Revised Chukchi Sea Exploration Plan Errata

**(In response to a request for additional information from the
Bureau of Ocean Energy Management dated October 28, 2011.)**

RE: Responses to requests for additional information, dated October 28, 2011, for the revised Chukchi Sea exploration plan

BOEM AKR 30 CFR 550.231 - 15-day Review of the Shell Gulf of Mexico Inc. Revised Chukchi Sea Exploration Plan-2 nd Round of RFAIs						
Topic	RFAI	Section	Page	Comment	Response	Attachment
Air Quality	1	Exploration Plan (EP) Section 7.0	7-1	<p>Please provide the following additional information pertaining to the air emissions and air quality.</p> <p>The EP is sufficient in providing the filing and approval status of permits (in this case the air permit) that must be obtained to conduct the EP activities [30 CFR 550.213(a)]. However, CAA permitting captures only offshore stationary source emissions. The scope of NEPA analysis is larger.</p> <p>This section is missing data that reflects total emissions generated from all sources, regardless of whether the sources are stationary or mobile, including aircraft, marine vessels (including all propulsion engines), onshore mobile vehicles, and onshore

FIGURE:
3.7.3-1

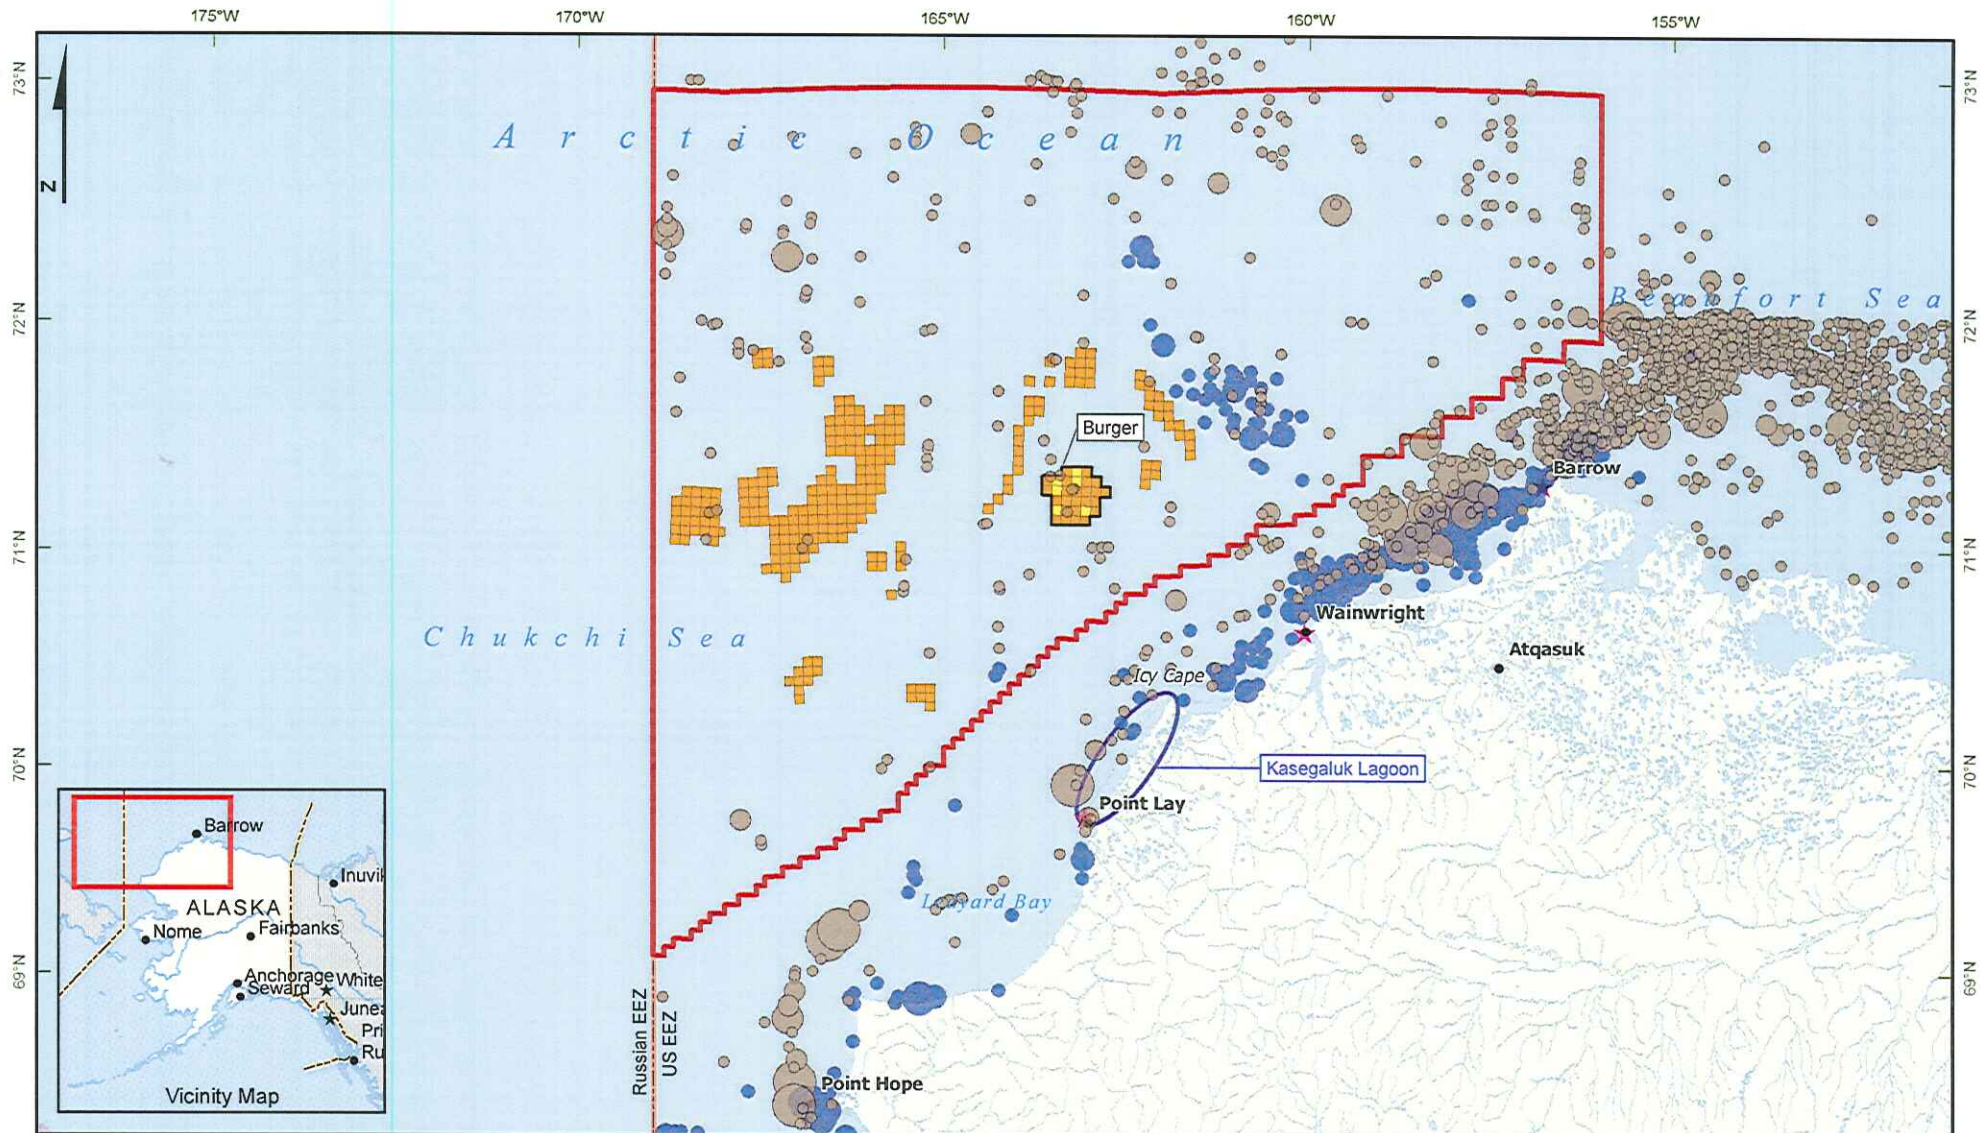
Fish	14	EIA 3.5.1	3-33	Please identify the types of demersal fish assemblages associated with the designations "I" through "VI" referenced in Figure 3.5.1.2.	As is labeled in the legend for Figure 3.5.1-2, see Table 3.5.1-2 for the demersal fish species within each assemblage.	No
Proposed Action	15	EIA 2.2	2-5	Please provide an estimate for the number of trips that the shallow water landing craft may make from the drill site to Wainwright and return.	Wainwright will be used on a contingency basis when travel to or from Barrow and the drillship is not possible. In addition, the landing craft, if used out of Wainwright, will not transit to the drillship. It will transit to an offshore supply vessel and offload its cargo. On a contingency basis, it is estimated that there may be 10 transits to an offshore supply vessel.	No
Marine Mammals	16	EIA 3.7.3	3-79	Please clarify apparent inconsistency between the figure caption (which references beluga whales and gray whales) and the legend (which references beluga whales and ringed seals).	The figure 3.7.3-1 incorrectly listed the ringed seal in the legend. The blue dots in the figure represent the total number counted in sightings for gray whales. The figure has been corrected and is attached (Attachment RFAI 16).	Yes
